Prepared for
Art Gallery of New South Wales Trust

Date
6 November 2020

Section 4.55(2) Modification

Art Gallery of NSW Expansion - Sydney Modern Project

Figure 4. Proposed landscape changes
Source: GGN and McGregor Coxall Landscape Architects

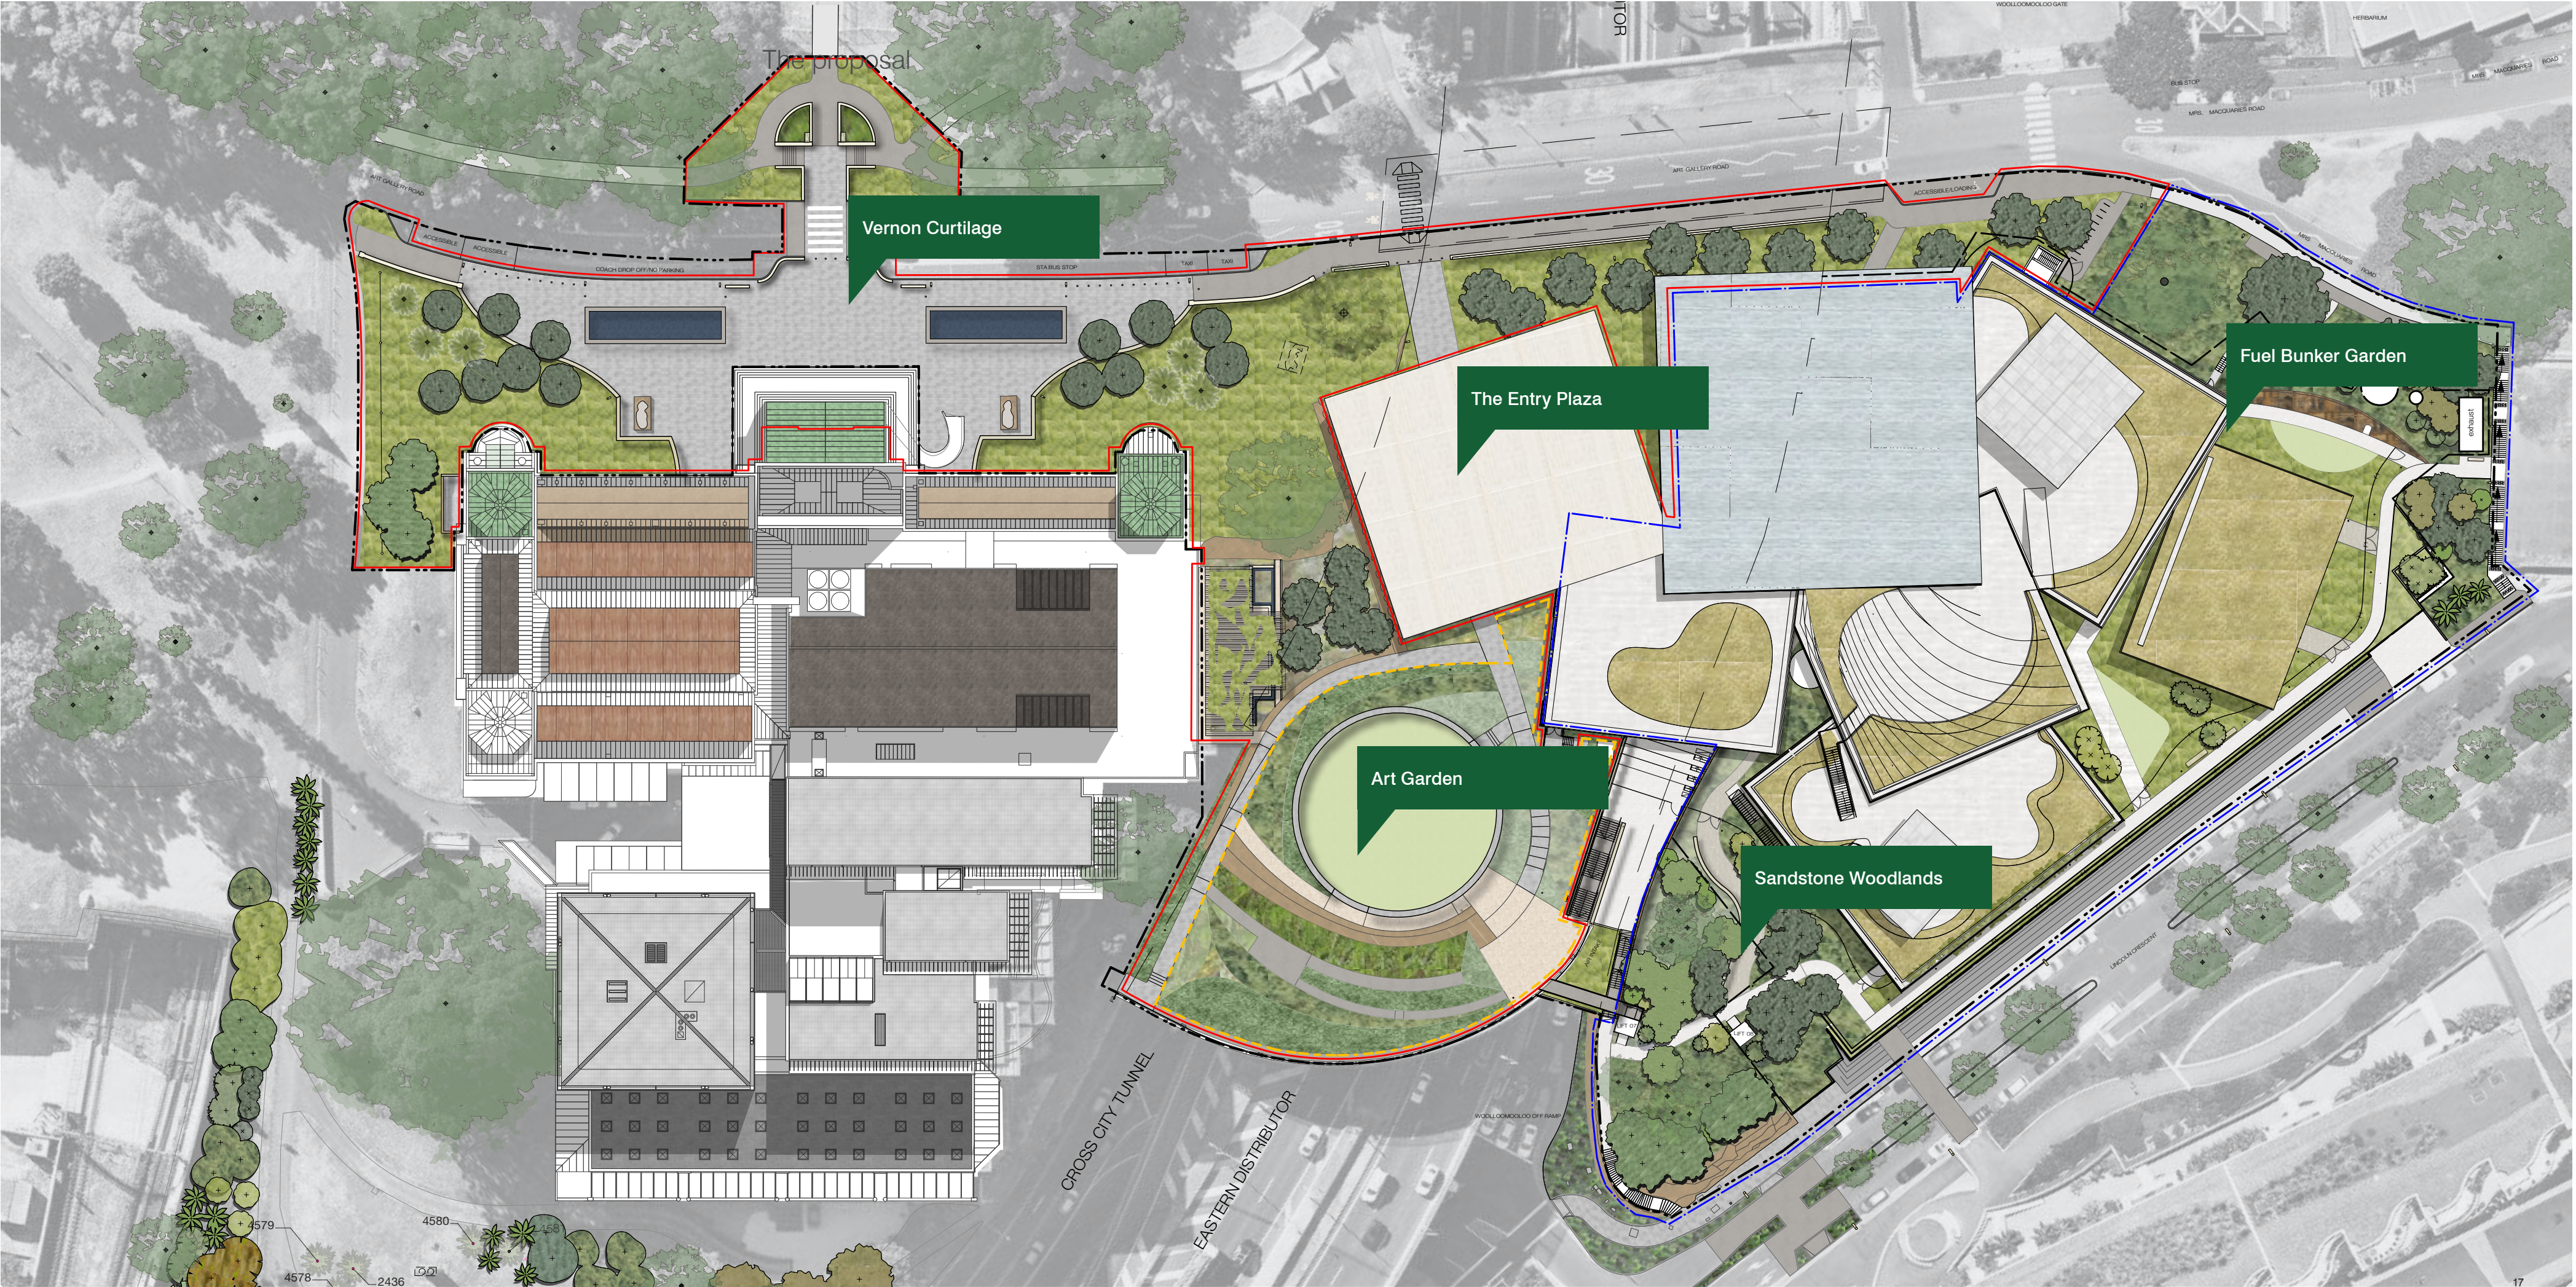
- Land bridge now incorporates a ‘gathering space’ bounded by a circular path system, surrounded by a sandstone channel capturing episodic water from the glazed roof canopy of the Entry Plaza and an elevated berm (‘Crescent Hill’) that will provide an acoustic barrier to the motorway below; an artwork commission zone has been indicated as the site for a future major art commission;

- Extant paved area on land adjacent to the land bridge and adjoining the existing Gallery building (former ‘Northern Sculpture Court’) is proposed to be reinstated as a terrace area which will be accessed predominantly internally from the existing Gallery building and used as a sculpture terrace and, as required, for Gallery programming and events. It will have a trellis structure with planting over, and be bordered by a water feature that will distinguish it from the remainder of the land bridge;

- Minor changes to planting areas in terms of tree/shrub/groundcover placement, refinements to plant palette, and an increase in proposed tree planting numbers;

Figure 6. Proposed Landscape Plan of the Vernon Curtilage under the Proposed Modification
Source: Gustafson Guthrie Nichol (GGN) Landscape Architects and McGregor Coxall Landscape Architects

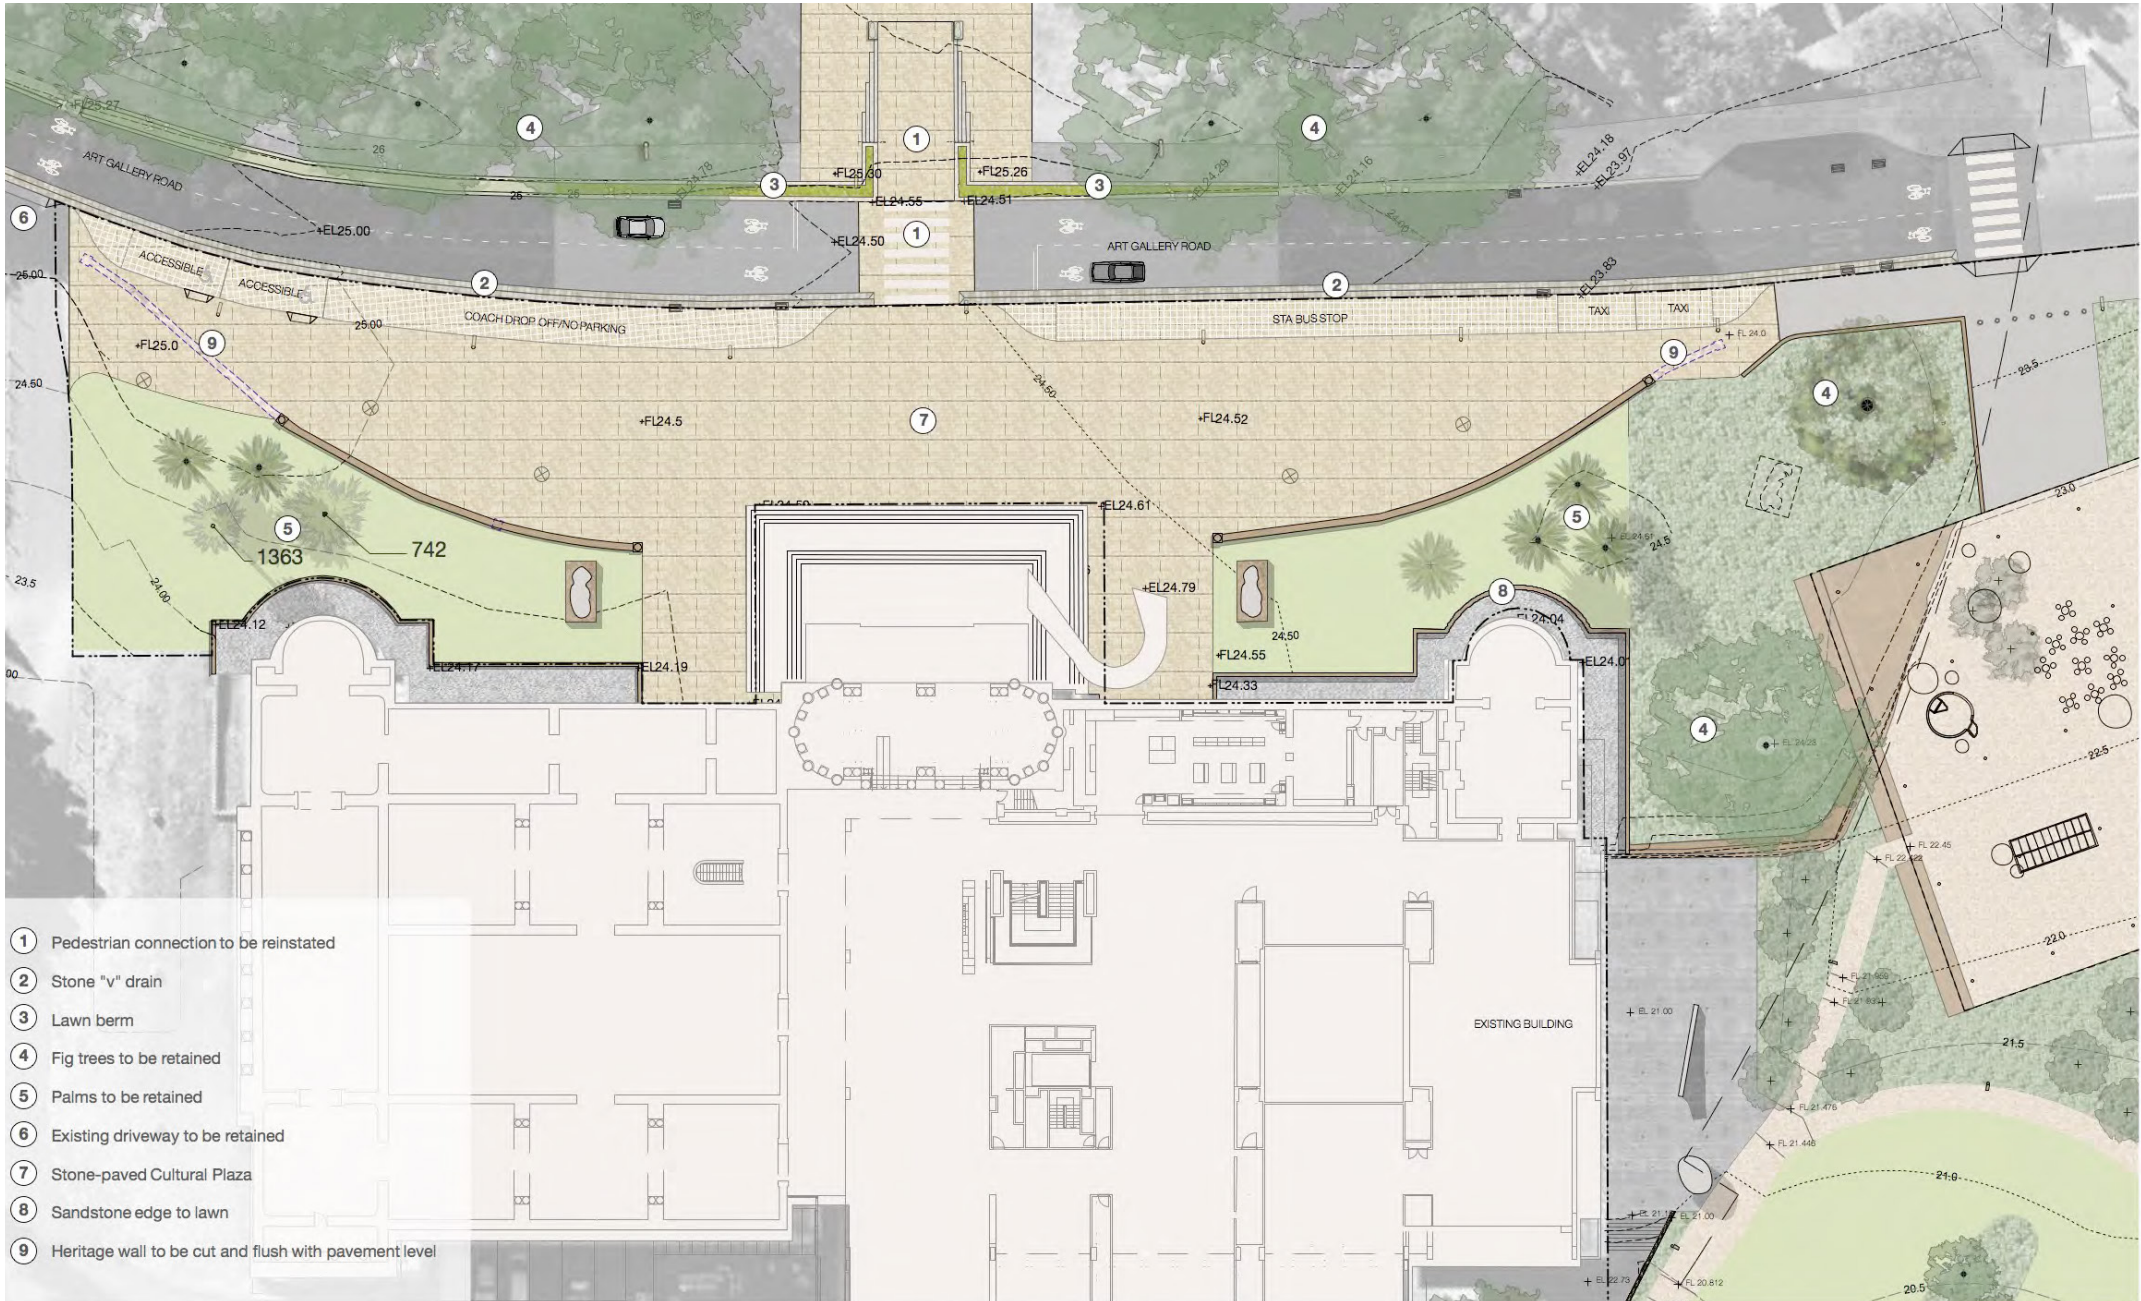
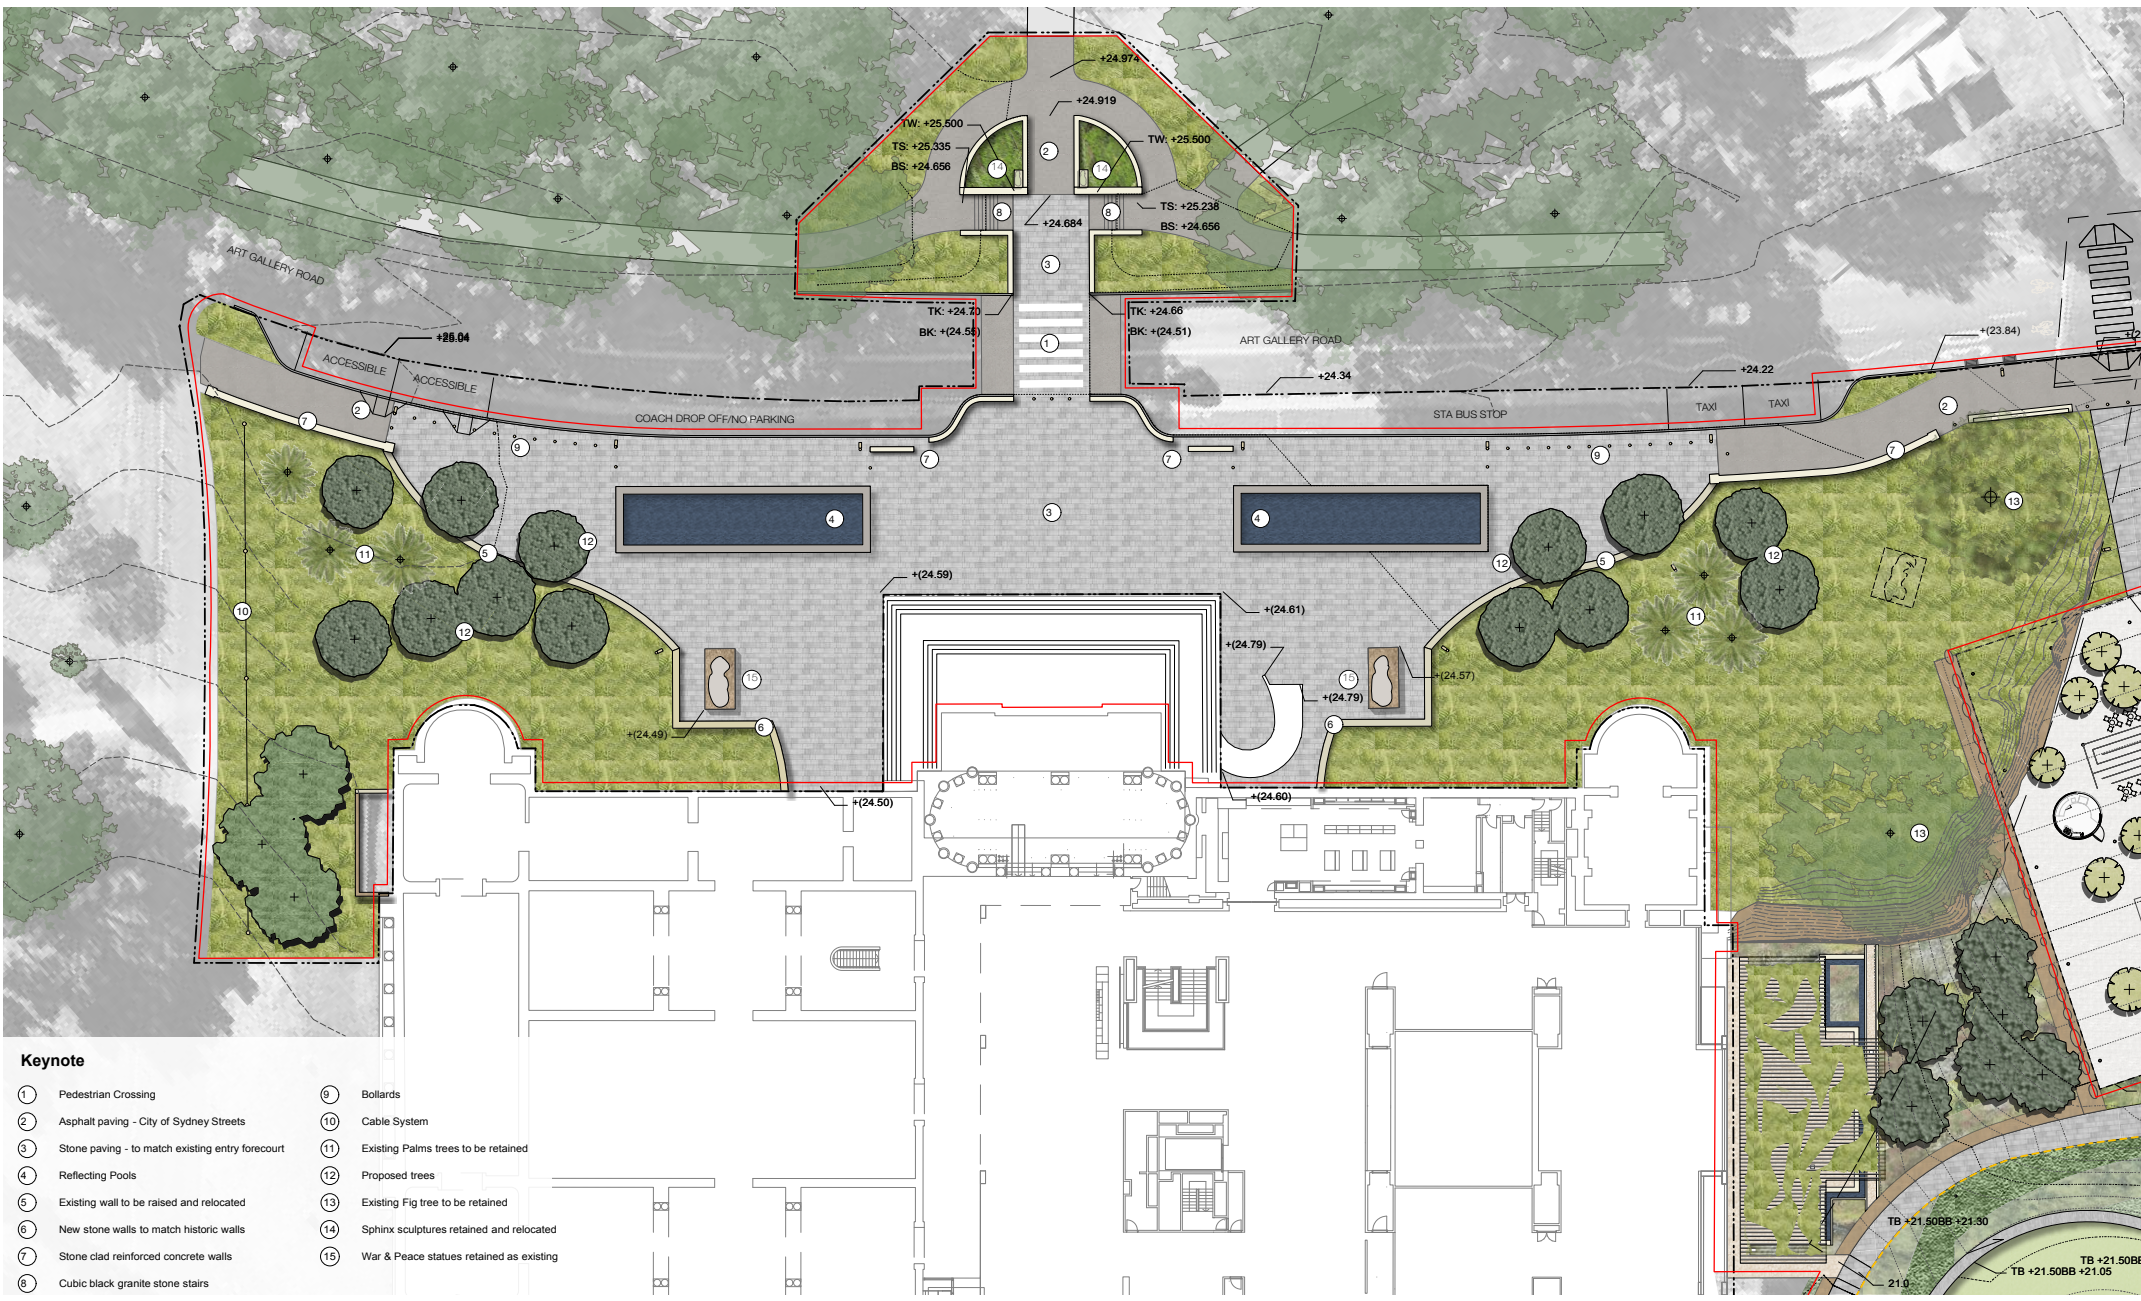
- Two new reflection pools positioned symmetrically in front of the existing Art Gallery of NSW building entrance
- New paving to the forecourt
- New bollards fronting Art Gallery Road
- New tree planting
- The existing stone wall surrounding the forecourt is to be partly retained and partly relocated with reuse of the existing stone
- New ramps, stairs and paving to match the forecourt in The Domain (far side of the Art Gallery Road pedestrian crossing) where possible reusing existing materials

“Two new reflecting pools are introduced, positioned to maximise the reflection of the portico and sized to help give scale and structure to the new forecourt.”
